# Bloomfield

Bloomfield Avenue (Route 189) and Park Avenue (Route 178) Intersection – Road Safety Audit

November 3, 2016

Figure 15. Short term recommendations

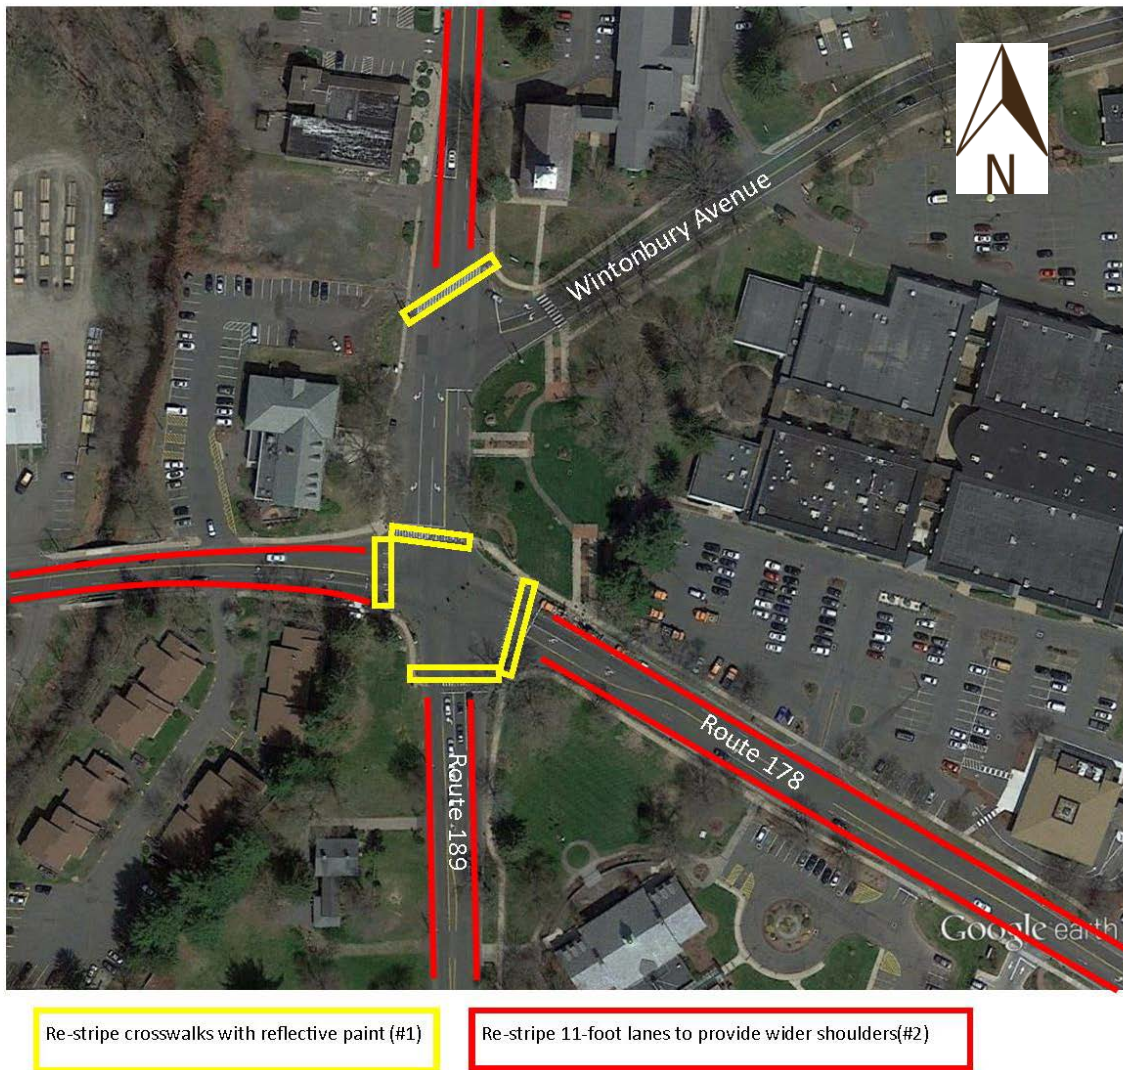
1. Restripe the crosswalks at the intersection of Route 189 and Route 178 with reflective paint.

2. Restripe Route 189 and Route 178 with 11-foot lanes to provide wider shoulders.
3. Replace any of the non-bike friendly catch basin grates on state roads and Town to replace any of the non-bike friendly grates on town roads.
4. CTDOT and Town to continue to evaluate and pursue Route 189/Route 178 roundabout concept.

**Figure 16. Rectangular Rapid Flashing Beacon (RRFB)**

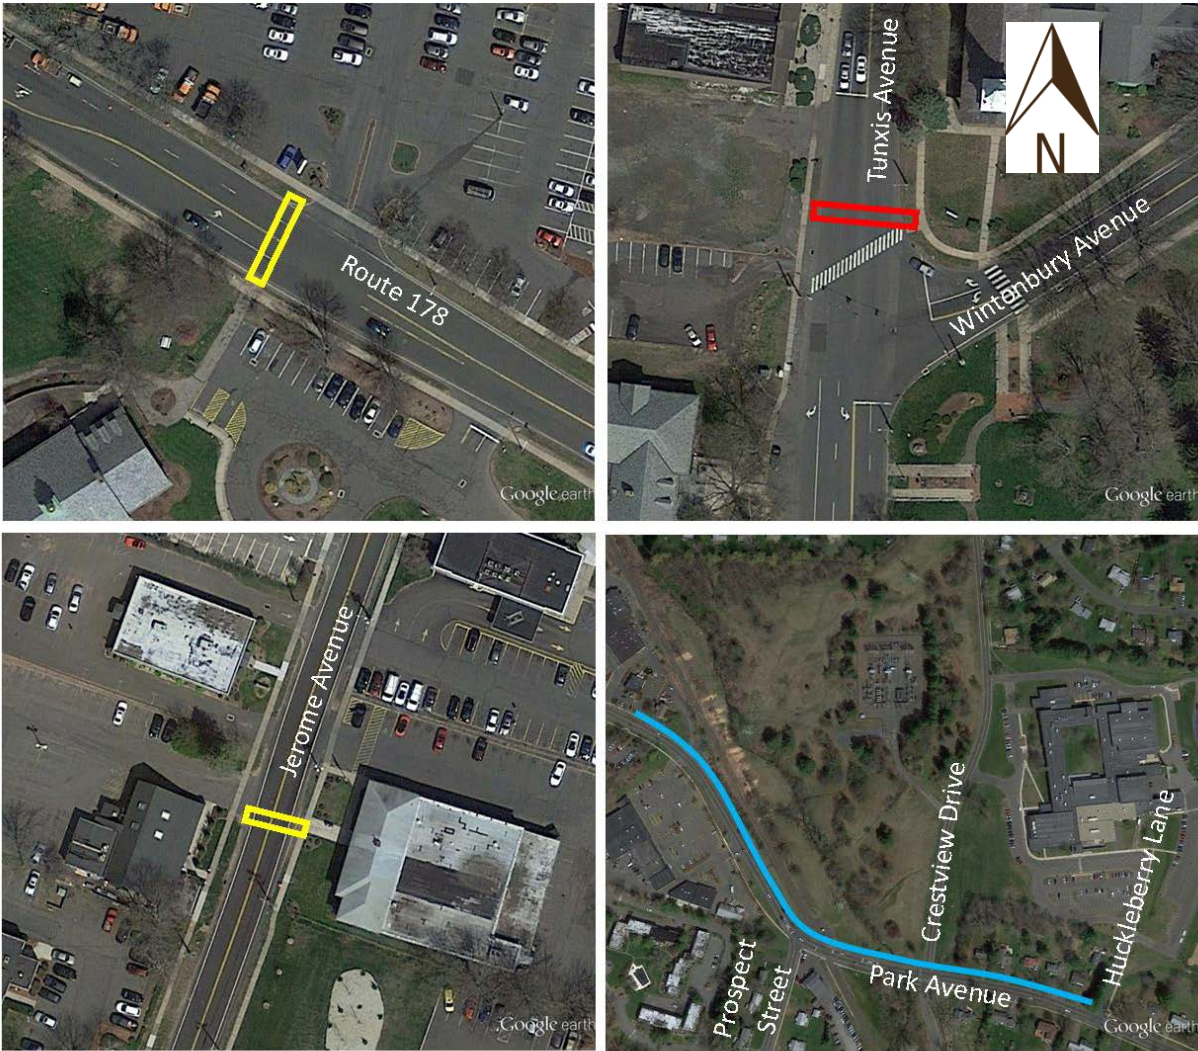
1. Town to coordinate with CTDOT to evaluate potential mid-block crosswalk on Route 178 at the Town Hall and Town to evaluate potential mid-block crosswalk on Jerome Avenue at the post office. Rectangular rapid flashing beacons (RRFB) or other advanced pedestrian safety measures should be considered as part of mid-block crossings (Figure 16).

2. Town to coordinate with CTDOT to consider realigning the skewed crosswalk on Tunxis Avenue at Wintonbury Avenue.
3. Town to coordinate with CTDOT to consider advanced pedestrian safety features such as RRFB as part of any roundabout design at the intersection of Route 189 and Route 178 (Figure 16).

Figure 17. Medium term recommendations

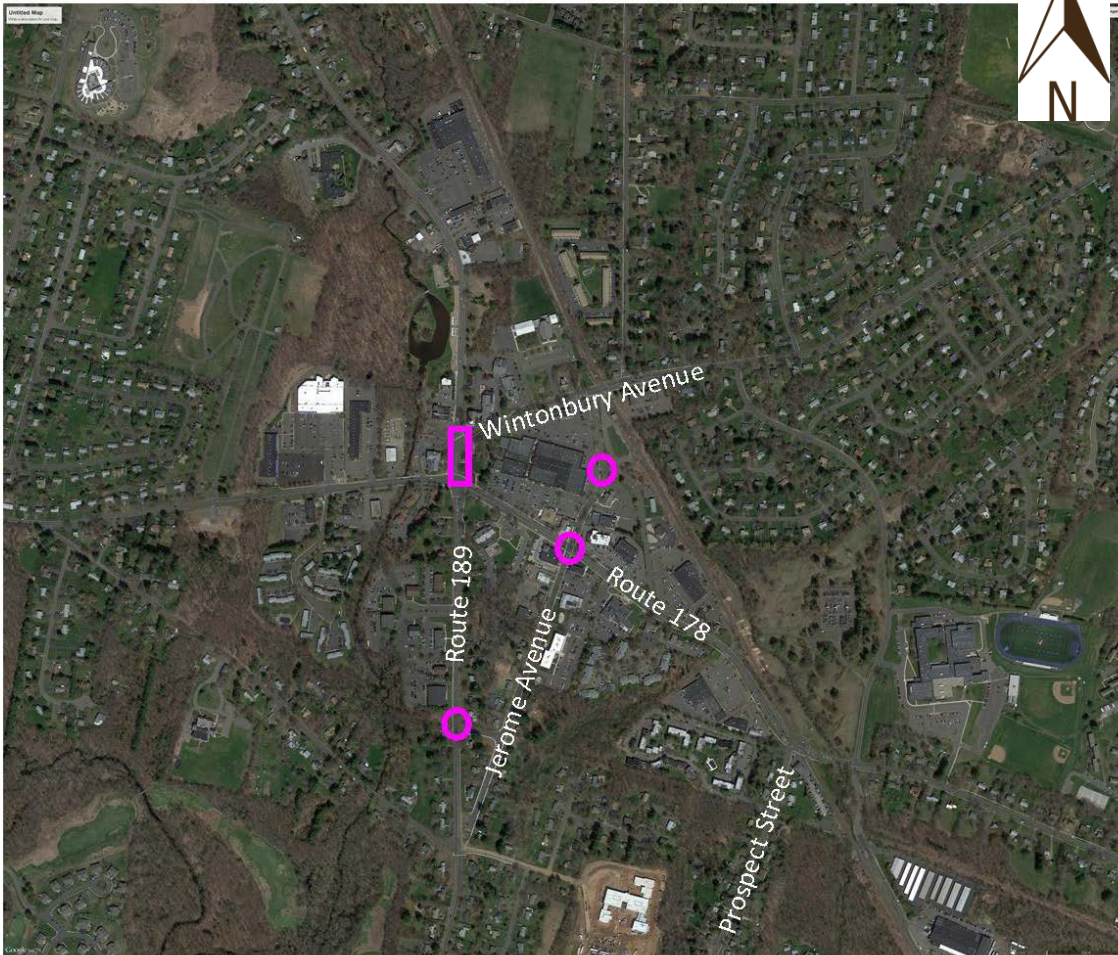
Evaluate mid-block crosswalks (#1)

Consider re-aligning skewed crosswalk (#2)

Extend sidewalk on north side of road (#3)

6. Town to extend the sidewalk on the north side of Park Avenue to connect with the High School.

Figure 19. Long term recommendations

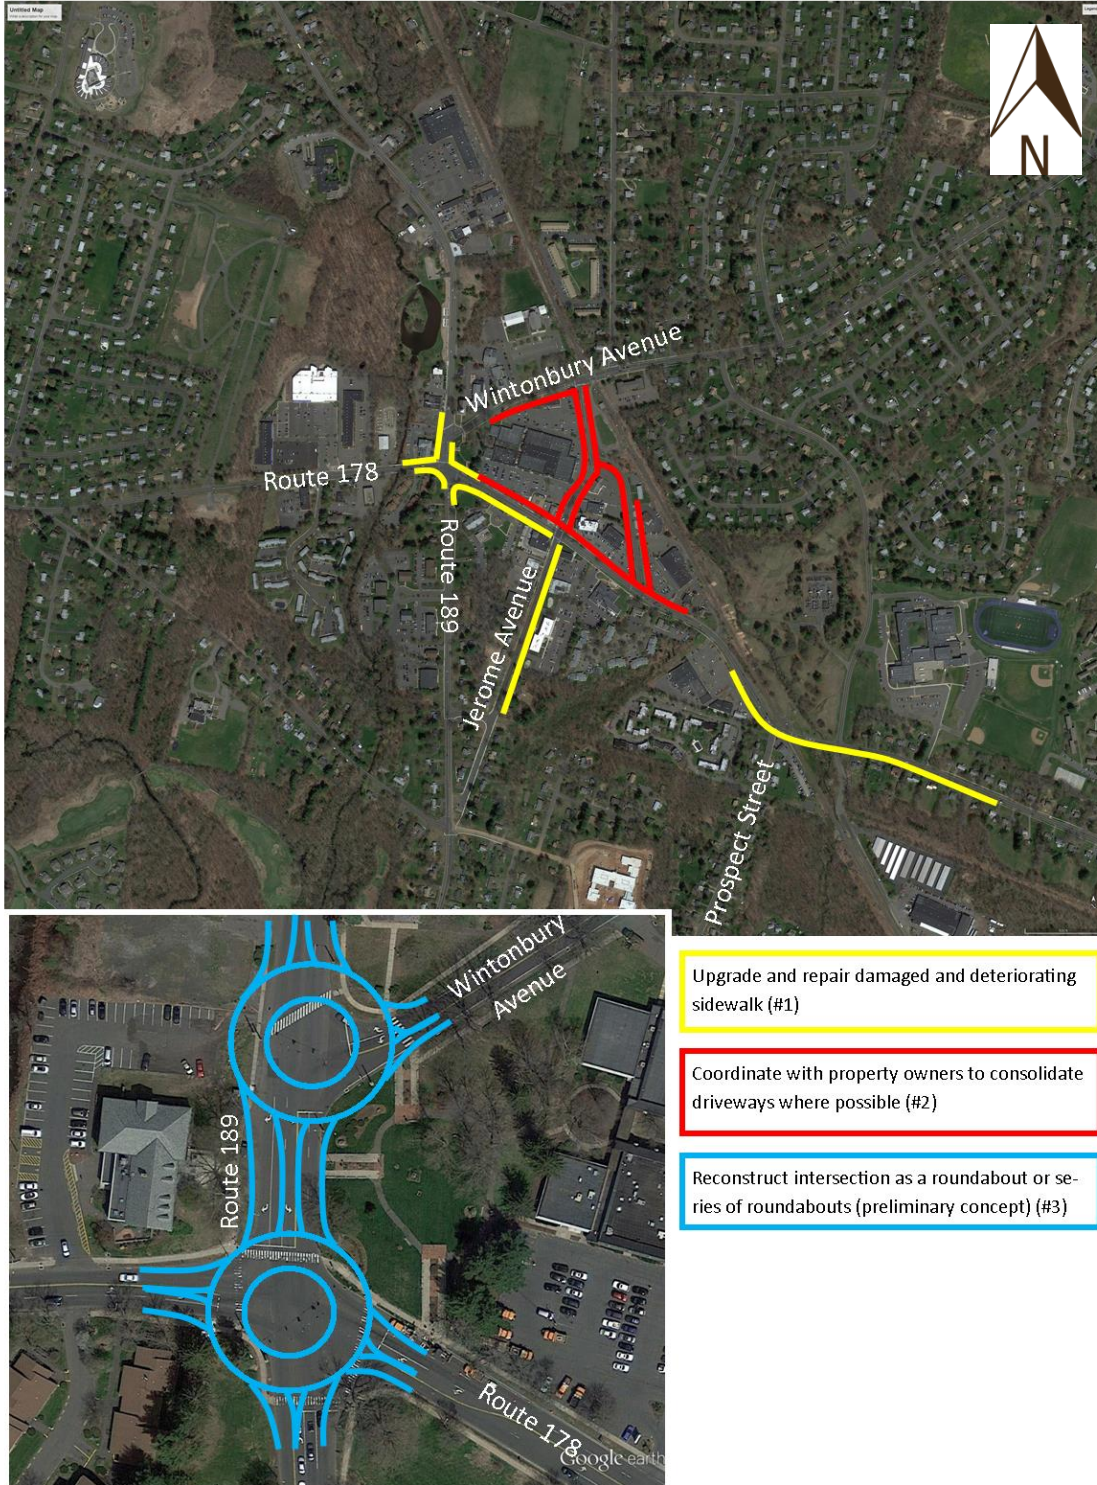
1. Town to upgrade and repair damaged and deteriorating sidewalks. Areas that were noted as being in most need of upgrade and repair include:
  - a. Surrounding the intersection of Route 178 and Route 189.
  - b. The south side of Route 178, especially approaching the High School and near Town Hall.
  - c. The east side of Jerome Avenue.
2. Town to coordinate with property owners to consolidate driveways where possible.
3. Town to coordinate with CTDOT to reconstruct intersection of Route 189 and Route 178 (including adjacent intersection of Wintonbury Avenue and Route 189) as a roundabout or series of roundabouts.
